CYRPUS ANVIL MINING CORPORATION  
CONCENTRATOR REVIEW

J.B. Reid  
F.J. Meyer

AMAX OF CANADA LIMITED

December 23, 1983

Summary Table of Mill Workforce

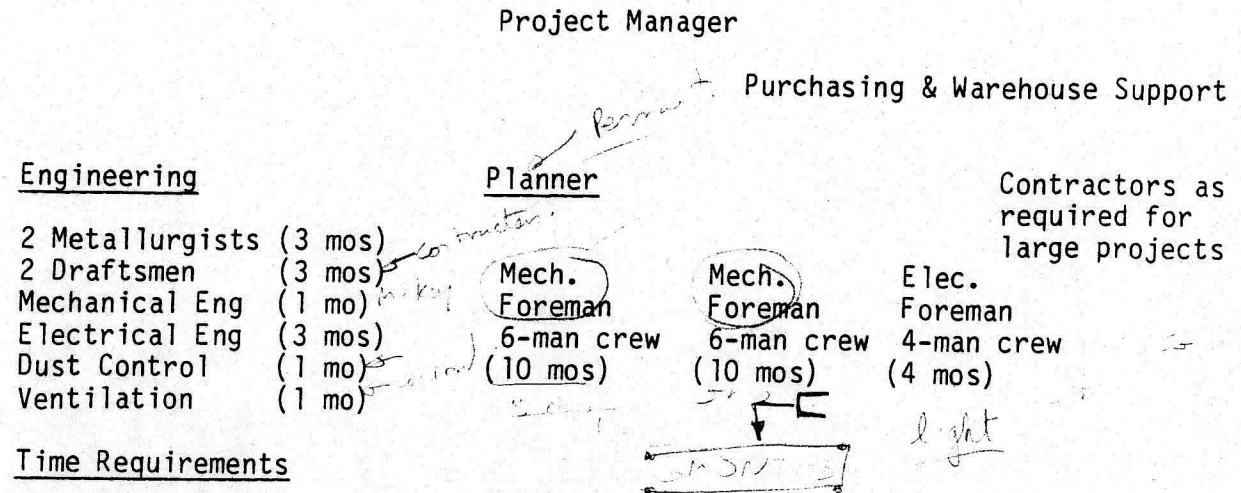
68  
158 CAMC → 195

adds - 9 millrights plus 2 vacat = 11  
5 instrument (oversite)
